Submissions Report

Karuah Pit Consolidation Project
Modification 2 (MOD2)
Development Consent DA265-10-2004

Andersite Road, Karuah

Prepared on behalf of Hunter Quarries Pty Ltd

Figure 5: Location of Proposed Highwall Extraction Area within Proposed Consolidated Extraction Area.

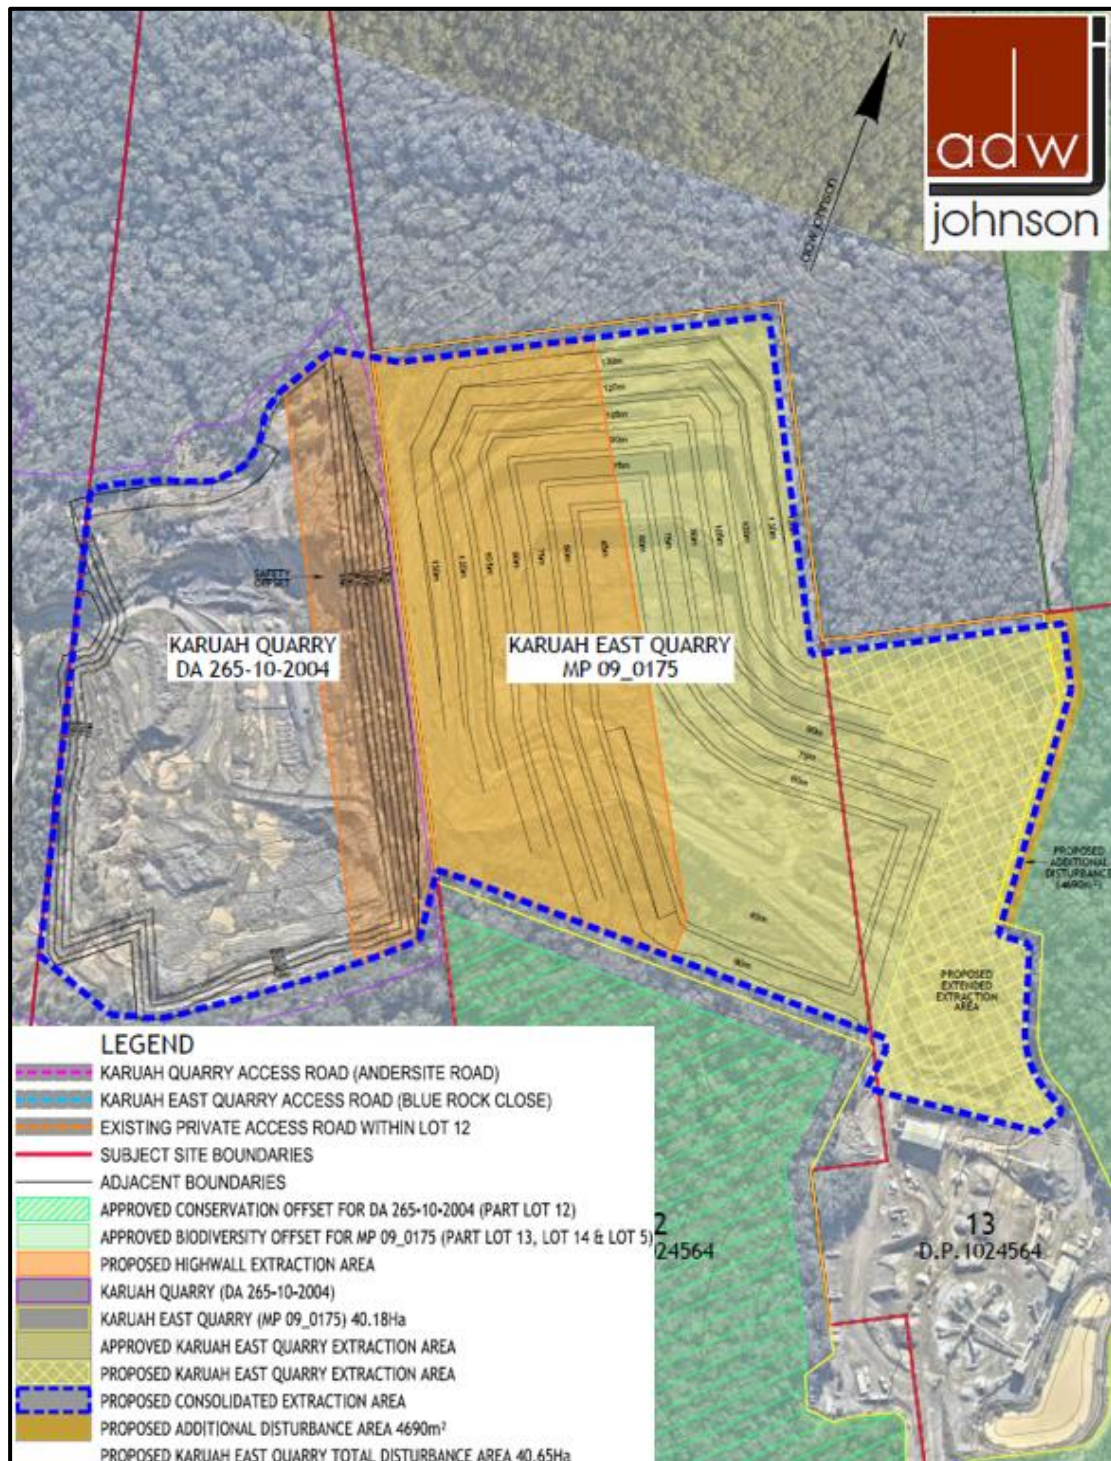
1. A standalone KEQ Groundwater Management Plan will be prepared within 6 months of determination of the concurrent modification applications (MOD2 to DA265-10-2004 and MOD11 to MP09_0175).
2. Commitment to install two (2) new monitoring bores (on Lot 11 DP 1024564 and Lot 5 DP838128) as shown in **Figure 4** below to be completed within 18 months of determination of the concurrent MOD2 and MOD11 applications.
3. Until items 1 and 2 above have been completed, extraction will be limited to the current approved extraction areas at KHRQ and KEQ and the 'Proposed Highwall Extraction Area' within the CEA on Lot 11 and Lot 12 DP1024564 as shown in **Figure 5** below.

Table 5: Two-Way Mid-Block Traffic Volumes

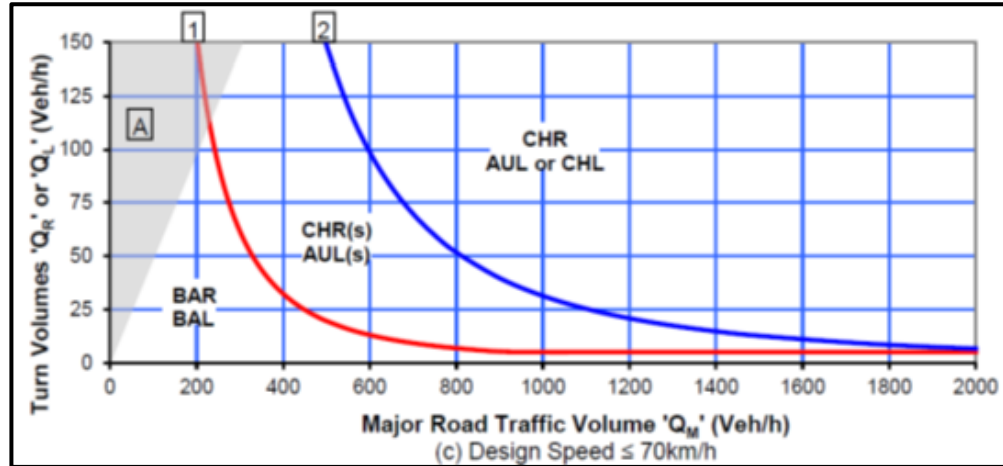
Transport for NSW (TfNSW)	
No objection to the proposal with clarifying detail requested. Intersect Traffic have prepared a response to the matters raised by TfNSW, which is provided in Appendix E.	
The following additional information was requested: 1. Sensitivity testing should be informed by the quarry's peak operational output capacities, rather than unsupported or outdated figures (from weighbridge data), to ensure traffic volumes accurately reflect maximum potential site activity.	The Traffic & Transport Impact Statement (TTIS), submitted as part of both the MOD2 and MOD11 applications, was developed on the basis of applying conservative assumptions to determine the maximum (or peak) output capacity of each quarry (KHRQ and KEQ) as restricted by weighbridge capacity at each quarry. This approach has been applied in the context of: - very low overall total vehicle movements, - heavy dominance of quarry-related traffic, and - exclusive use of Andersite Road and Blue Rock Close by the Applicant (i.e. no other premises or landholdings are accessed). Accordingly, the purpose of providing the weighbridge data in the TTIS was to provide evidence of what the maximum capacity is (i.e. 70 vtpm with 35 loaded exit movements and 35 return movements at KEQ). A further allowance for services vehicles was included (i.e. 10 vtpm with 5 inbound movements and 5 outbound movements). <i>Note – The weighbridge at KEQ utilises a more time-efficient site layout and processing system than KHRQ and therefore this has been conservatively adopted as the maximal output for KHRQ.</i>

Analysis of this data confirms that the local road network is operating with extremely low two-way mid-block traffic volumes which are less than the thresholds for uninterrupted flow conditions at intersections as sourced from *Austroads Guide to Traffic Management Part 3 Traffic Studies and Analysis* and reproduced below.
